Memorandum

Correspondence # TTCES-PTLD-2024-006

Subject: **Visual Impact Assessment of Key Observation Points 1, 3, and 5**

Tetra Tech understands that Carriger Solar, LLC (Applicant) is developing the Carriger Solar Project (Project), a solar photovoltaic (PV) electric generating facility that includes 160 (MW) of solar energy and 63 MW of battery energy storage in Klickitat County, Washington. The Applicant is seeking a Site Certification Agreement from the Washington Energy Facility Siting Council (EFSEC).

FIGURE 11

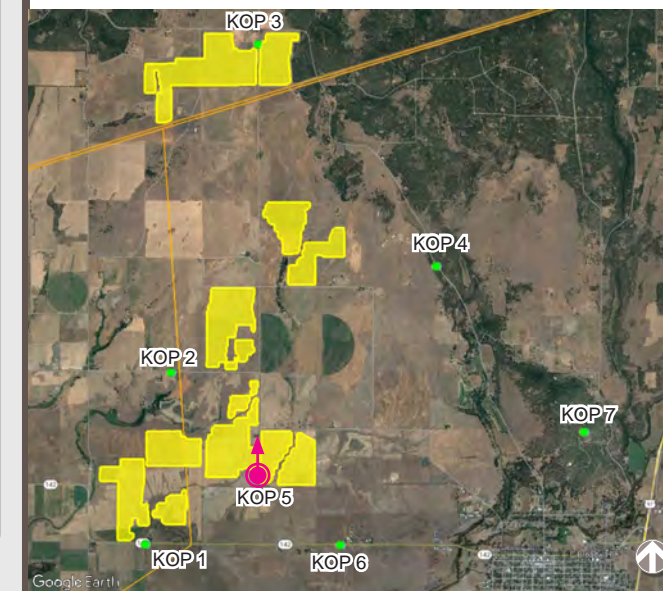
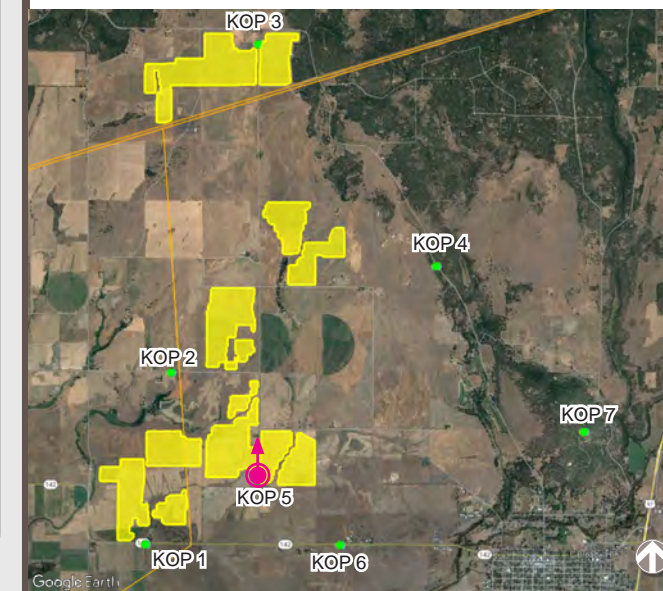
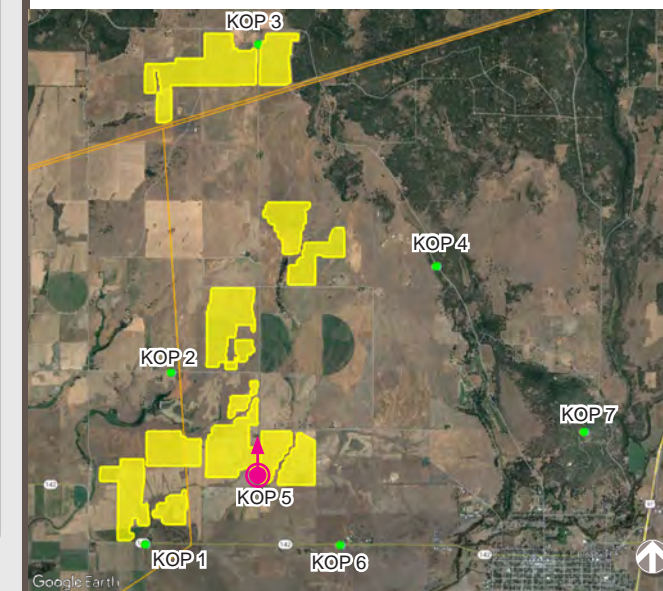
KOP 5 represents a view of the Project for drivers traveling north on Knight Road and the non-project participating residence (on tax parcel 04151300000200) adjacent to this viewpoint. This KOP also represents views of the south side of the MPE. Figure 11 presents the original simulated view of Project components from KOP 5. Figures 12 and 13 present the updated simulated view of the Project components, with increased setbacks. Figure 12 depicts the view of the panels at flat orientation while Figure 13 depicts the view of the panels at maximum tilt near sunset (facing west).

During the majority of the day, the panels will be oriented closer to a horizontal alignment that allows views through the Project site, reducing attention to and contrast from the Project (see Figure 12). While the Project would begin to attract attention to the casual observer, the portion of the Project that would be visible would not dominate the landscape the majority of the day when the panels will be oriented closer to a horizontal alignment. In the maximum tilt orientation (Figure 13), the Project would begin to attract attention to the casual observer and begin to co-dominate the landscape along with the other existing structures in the vicinity that provide horizontal and vertical lines. Beginning to dominate the landscape is a “moderate” level of contrast per the BLM contrast rating definitions. The maximum tilt visual experience would short-term both because of the short amount of time each day the panels would be at maximum tilt orientation and for the short amount of time travelers would see the panels while driving down Knight Road. In addition, with the increased set back from the roadway, the view orientation focuses either down the roadway or over the panels toward the existing structures in the middleground and the hills and mountains in the background. The viewer’s focus will be on the road and existing transmission line and fence lines and the Project no longer demands attention or dominates the landscape due to the increased setbacks and modified fence design. Therefore, the Project would introduce moderate contrast for travelers on Knight Road at KOP 5.
